HOW LOOSE CAN RIVETS BE?

THAT'S A GOOD QUESTION, ONE THAT HAS ARMORERS AND THEIR DIRECT SUPPORT CONFUSED ABOUT M2 MACHINE GUN RIVETS.

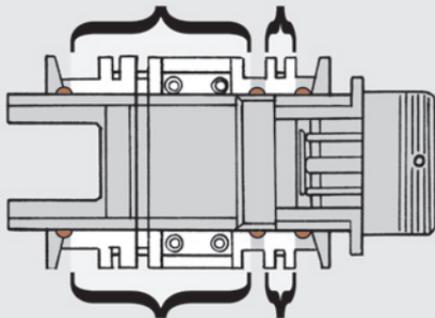
Armorers—Do the PMCS check in Item 14 on WP 0010 00-23 in TM 9-1005-213-23&P (Change 2). Check the receiver for cracks or movement of riveted components. Rivets are allowed to turn as long as there's no movement of riveted components. Item 14 says "If there are more than a total of eight loose rivets on the receiver or more than six loose rivets on the top plate, bottom plate or trunnion block, send to direct support." **Disregard that.** That will be changed to say "If there is movement of riveted components, send to direct support."

But it is OK for the feed pawl brackets to have some movement. The maximum allowable looseness or gap permitted between the belt holding ammo brackets and the side plates is 0.010 inch. The receiver is unserviceable if a 0.010 feeler gauge passes through the area between the rivets.

Does feeler gauge pass between rivets?

Direct support—Verify that there is movement of riveted components. If there is, the M2 is unserviceable and must be turned in for overhaul.
